GSI-191 ACRS Slide Presentation – November 19, 2010 (Non-Proprietary)

# Presentation to ACRS Sub Committee

## **AP1000™ Long-Term Cooling Debris Issues Resolution Supplemental Information**

# Follow-up Information From ACRS Meeting Nov 18, 2010 on GSI-191

# K/A<sup>2</sup> For AP1000 FA Debris Tests

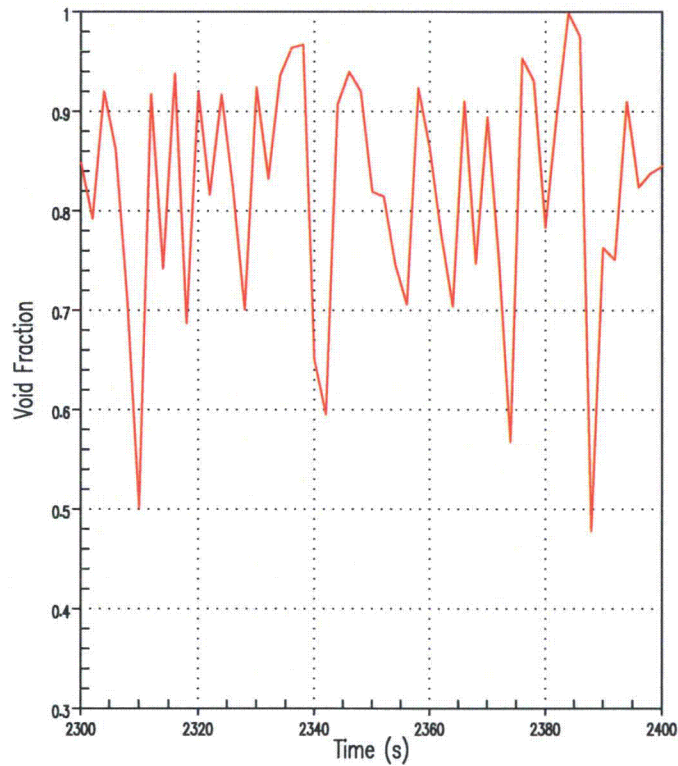
- Comments on K/A<sup>2</sup> Information
  - Note that the test based exponent results in a LARGER resistances, which means that the WEC approach is more conservative
  - Test #17 has the highest resistance but maintains margin to the acceptance criteria
    - This test is included even though it is considered an invalid test because the test protocol was not followed
  - Tests #36 & 37 (higher temp tests) have the lowest resistance
    - This shows that more margin is available which may be quantified in the future to allow higher operating fiber limits for AP1000

# Confirmation of CHF Results in WC/T LTC Results

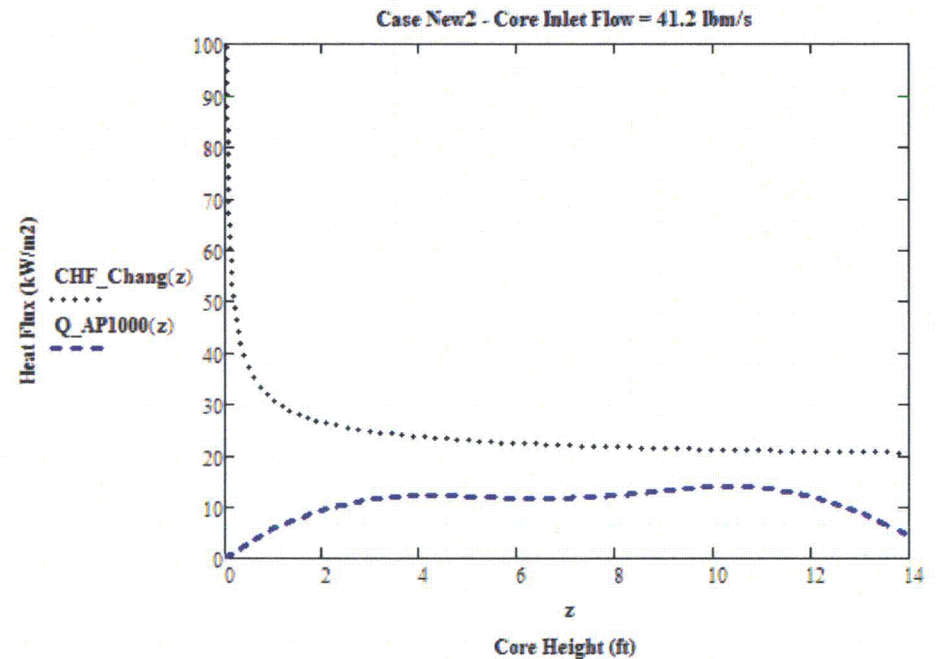
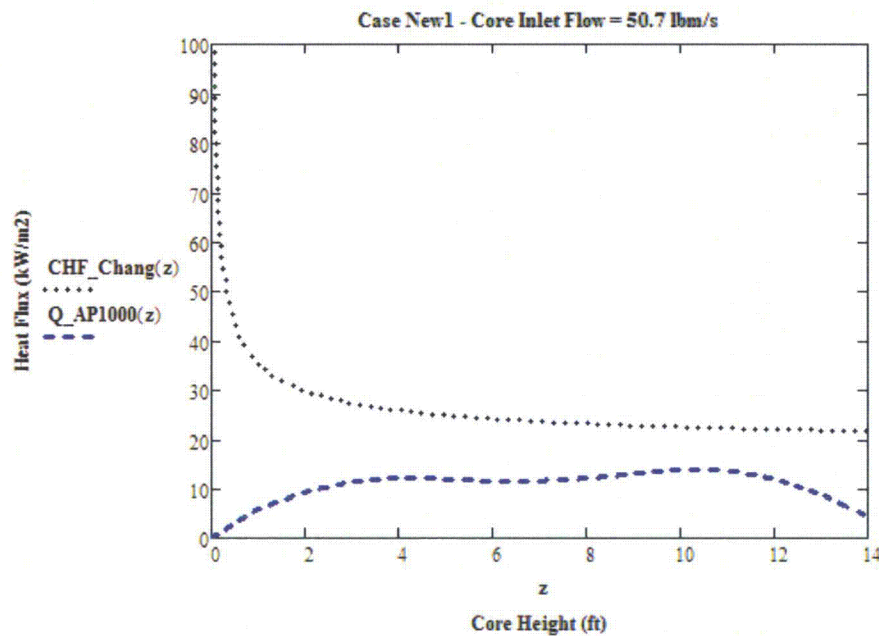
- CHF check against Chang (1991) correlation for New Case 1, New Case 2
